Black Hill Viasat: Site Plan Amendment No. 82018011A

ViaSat: Site Plan Amendment No. 820180110:

Amendment to remove a vehicle drop-off lane, adjust pedestrian circulation between the parking garage and building, relocate the trash enclosure, adjust the multi-use trail route and minor landscaping and lighting adjustments; on approximately 5.8 acres; CR 0.75, C-0.5 R-0.5 H-145T and Germantown Transit Mixed Use Overlay Zone, but reviewed under the TMX-2 zone; 2009 Germantown Employment Area Master Plan.

Figure 3 – Proposed circulation changes

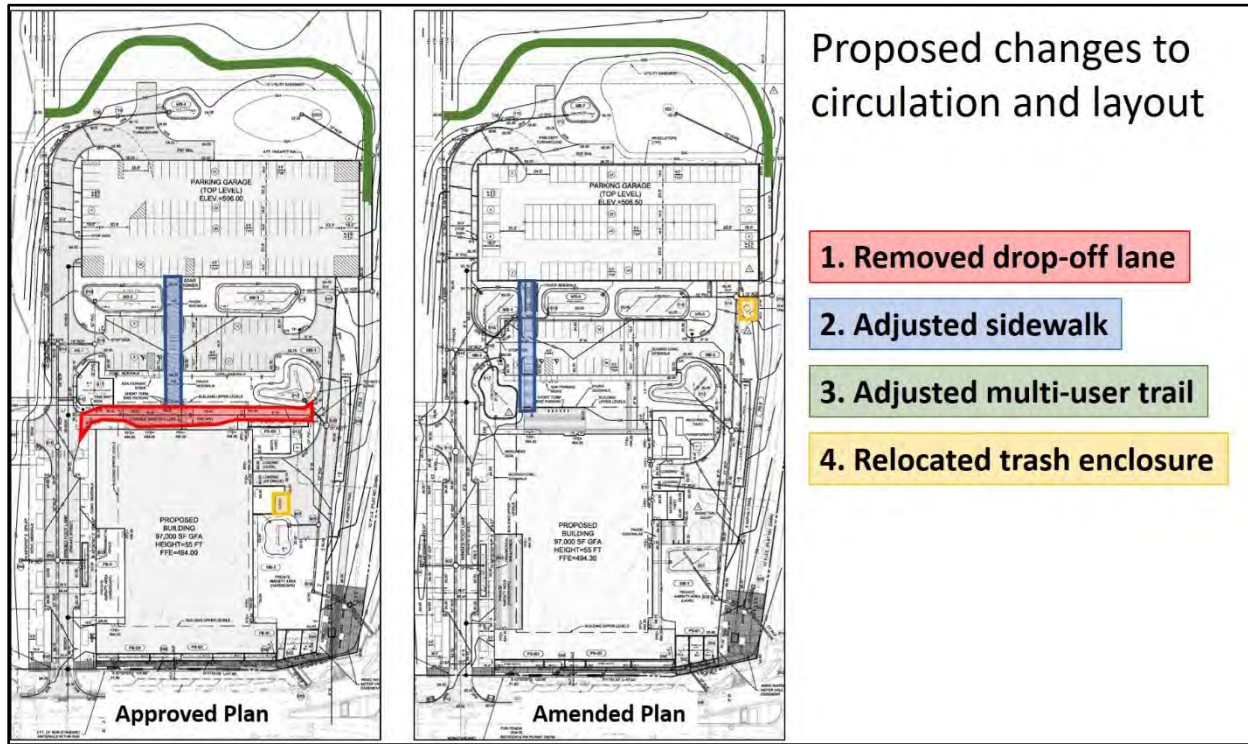
The most substantial of these requested changes is the removal of the vehicle drop-off lane adjacent to the eastern side of the main building. The drop-off was seen as redundant by the Applicant, and instead this area is proposed to become a larger front entry patio with landscaping. Other adjustments to circulation such as the sidewalk between the parking garage and building, and the multi-user trail were

for efficiencies in circulation. The other requested amendments are more administrative in scope and are largely a result of adjusting plan elements to accommodate the removal of the drop-off lane. Figure 3 below highlights the major changes to circulation that are apparent on the Site Plan.

The location and design of the pedestrian and bicycle circulation proposed by the Amendment is safe, adequate, and efficient. The two changes to pedestrian circulation are the re-alignment of the sidewalk that connects the building to the parking garage, and the re-alignment of the multi-use trail around the perimeter of the Property. The sidewalk is being realigned to create a direct path between the garage and the main building entrance, since the vehicle drop-off lane is removed. The sidewalk is similar in size and function to the previously approved sidewalk, and only shifts the alignment a few feet to the north. The multi-use trail changes push the trail closer

to the edge of the eastern edge of the Property, providing a larger lawn area between the parking and the trail that can be used as an amenity by employees. The intent and character of the trail remains the same and the adjusted alignment only moves the trail in one section.

The location and design of vehicle circulation on the ViaSat Property continues to be safe, adequate and efficient. The Amendment removes a one-way drive aisle previously shown running along the eastern edge of the building, which functioned primarily as a drop-off area. The Applicant no longer finds this necessary and instead intends to expand the entry patio and provide additional green planting areas. Emergency and service vehicles still have adequate access to all sides of the building through the parking lot aisle. Removing the one-way drop-off aisle makes the vehicle circulation on the Property more efficient by eliminating a redundant drive aisle, and pedestrian safety is increased through a reduction in the number of crosswalks between the parking garage and building. The adjustments to the parking lot are in response to the relocated sidewalk between the parking garage and building. The visitors' parking lot maintains the same circulation but the pedestrian crossing has moved slightly to the north, and the parking spaces in the garage have adjusted to accommodate a shift in the elevator and stair tower. These changes in parking do not change the parking count or overall circulation of vehicle within the lots.

Figure 4 – Proposed decorative light columns

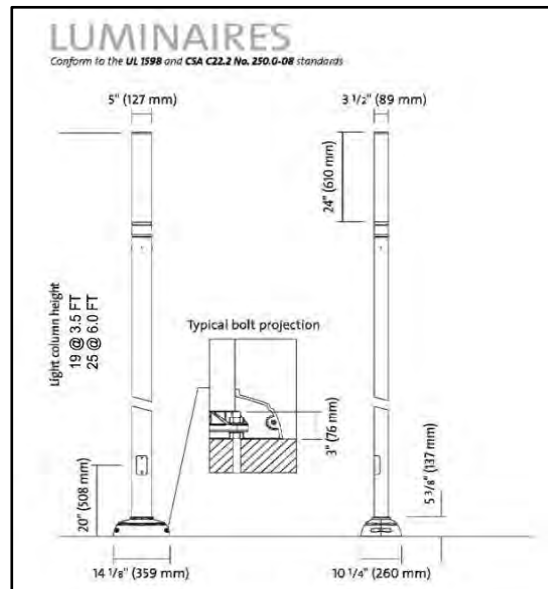
The location and quantity of landscaping and lighting proposed by the Amendment is safe, adequate and efficient. The changes made to landscaping are minimal and are a response to changes made in the alignment of on-site sidewalks and the multi-use trail, and the removal of the drop-off drive. The type and quantity of plant material is substantially similar and it maintains the intent of providing shade and screening. The adjustments to site lighting include a new light fixture over the relocated trash enclosure, adjusted lighting locations in the surface parking lot because of the relocated sidewalk, and an adjustment of pole locations on top of the parking garage. The amended lighting continues to provide ample security and visibility lighting around the building and circulation areas, and the light impacts on the Property edge are negligible and continue to meet code requirements. The Amendment also replaces the manufacture and style of the decorative light columns that will be used in the linear gateway park. The previous lights were rectangular and the new lights are more oval in shape. The Amendment maintains the same height and decorative purpose as the previous lights.
